# PRODUCT BULLETIN

## Sliding Fifth Wheel Air Cylinders

### Jost International Announces Changes to Sliding Fifth Wheel Air Cylinders

Figure 3

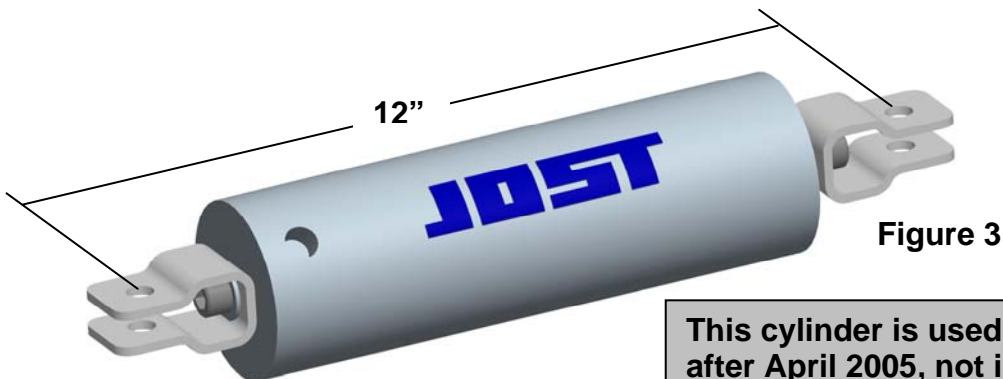
Figure 3 shows the new design air cylinder which does not require an external return spring because the return spring is attached to the mechanism.

This cylinder is used on sliders shipped after April 2005, not interchangeable with either cylinder shown above.
